SUNDRY NOTICES AND REPORTS ON WELLS
Do not use this form for proposals to drill or to re-enter an abandoned well. Use Form 3160-3 (APD) for such proposals.

8. Well Name and No.
ESU # 3

9. API Well No.
30-015-05683

Permanent Abandonment of Federal Wells
Conditions of Approval

East Shugart Unit # 3

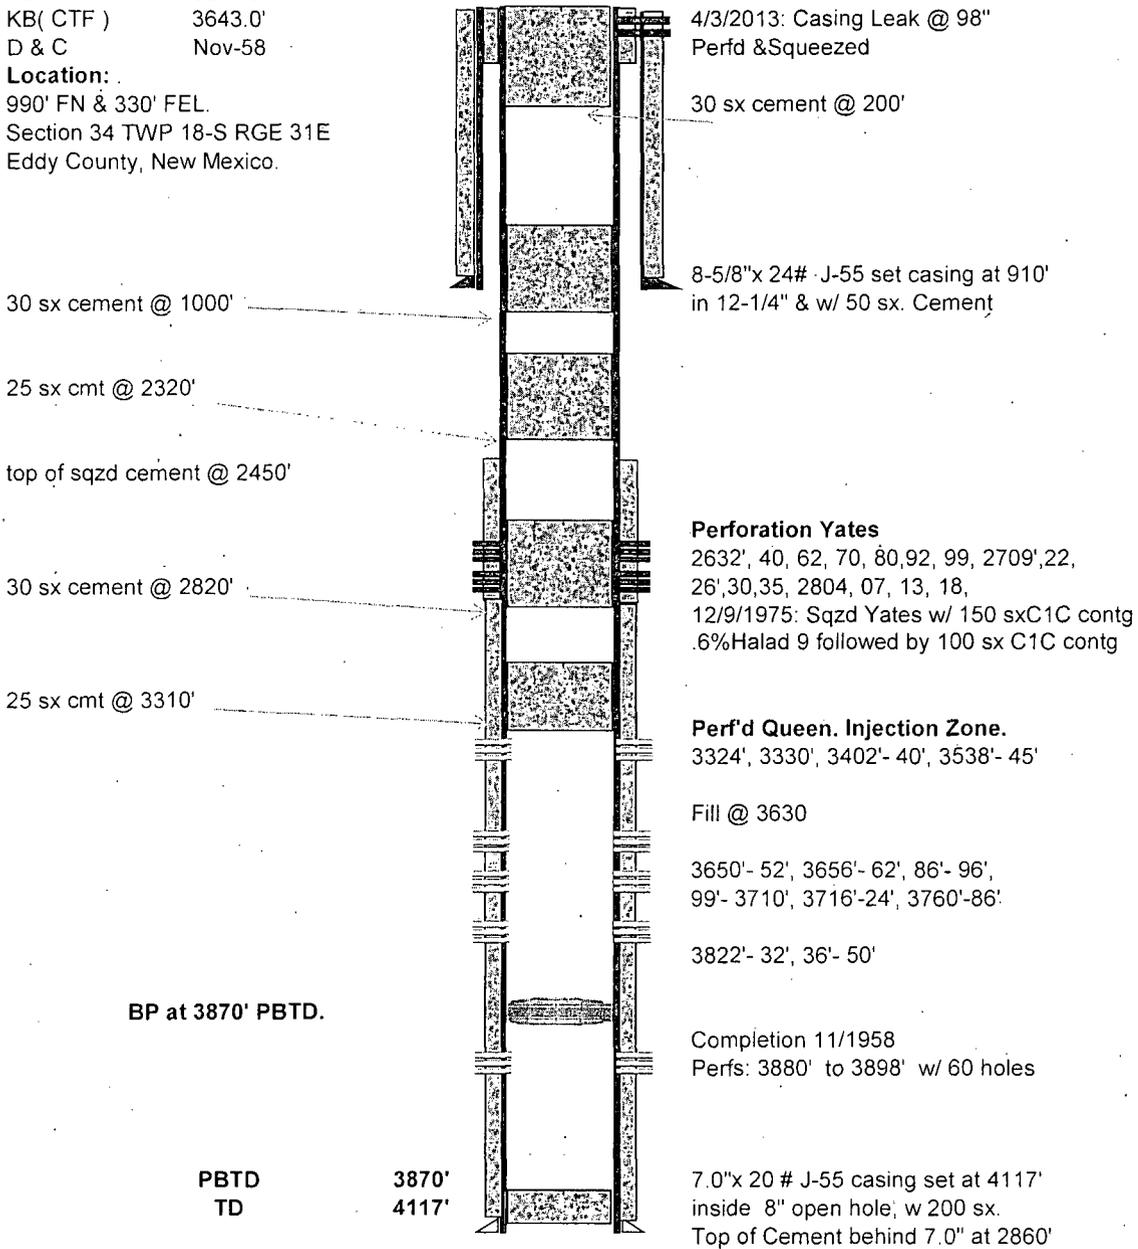
- 1) RIH w/ 2-3/8" tubing open ended to 3310' +- *Set CIRP 50-100' above top part @ 3324. WOC Tag no lower than 3200*
- 2) Pump 25 sk cement plug- pull up and woc, RIH & tag cement. If good pull tbing to 2820' +-
- 3) Pump 30 sk cement plug- pull up and woc, RIH & tag cement. If good pull tbing to 2350' +- *2140' - Perf/ISQZ cmt to 2020.*
- 4) Pump 25 sk cement plug- pull up and woc, RIH & tag cement. If good pull tbing to 1000' +- *960' - Perf/ISQZ cmt to 815.*
- 5) Pump 30 sk cement plug- pull up and woc, RIH & tag cement. If good pull tbing to 200' +- *Perf/ISQZ cmt*
- 6) Pump 30 sk cement plug up to surface- pull up and woc, RIH & tag cement. If good POH.
- 7) Remove BOP fill csg up w/ cement.
- 8) R/D plugging equipment, dig up & cut wellheads off - weld plate on csg's per BLM specs
- 9) Remove caliche from location and road put down BLM seed put up berm at entrance.

At cut-off verify cmt to surf. all annulus

Ground Level Dry Hole Marker Required

SEE ATTACHED FOR
CONDITIONS OF APPROVAL
